SERVICE BULLETIN

CHECK OF SUPPORT BEARING ON THE CRANKSHAFT AND OF THE BEARING BUSHING IN THE PROPELLER GEARBOX ON ROTAX_® ENGINE TYPE 912/914 (SERIES) SB-912-046UL SB-914-031UL

SB-912-046 SB-914-031

Check of support bearing on the crankshaft and of the bearing bushing of the propeller gearbox on $ROTAX_{\tiny{\textcircled{\tiny 0}}}$ engine type 912/914.

(Fig. 2

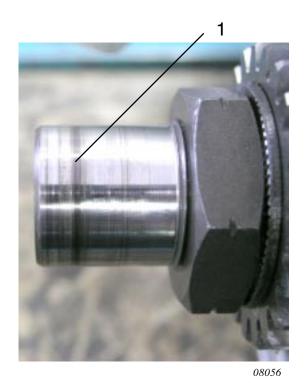
■ CAUTION: The pictures show one of several damage possibilities. Scoring marks in connection with discolouration is not permitted (see section 3.1).

If discoloration and grooves (1) are not removeable with Scotch Brite, engine must be sent to the authorized distributor responsible for the distribution area.

Replacement of propeller gearbox required if unusual scoring (2) in the bearing bushing is discovered.

- CAUTION: All work has to be performed in accordance with the relevant Maintenance Manual.
- Fix the crankshaft.
- Remove the propeller gearbox.
- Detailled check of crankshaft journal (1) and the bearing bushing in the gearbox housing (2) for scoring marks in connection with discolouration.

- ◆ NOTE: Conditional on operation, minimal or usual break-in marks are normal and can be ignored.
- If necessary clean the crankshaft stub with Scotch Brite until no discolouration is there. If the discolouration cannot be removed, engine must be sent to the authorized distributor responsible for the distribution area for repair/overhaul.

- On signs of scoring marks in the bearing bushing replace the whole propeller gearbox and check the oil filter
 for metal chips. If unusual marks of metal chips are detected in the filter mat, empty and clean the oil tank. Carry
 out an oil change. The replaced propeller gearbox must be sent to the authorized distributor responsible for the
 distribution area.
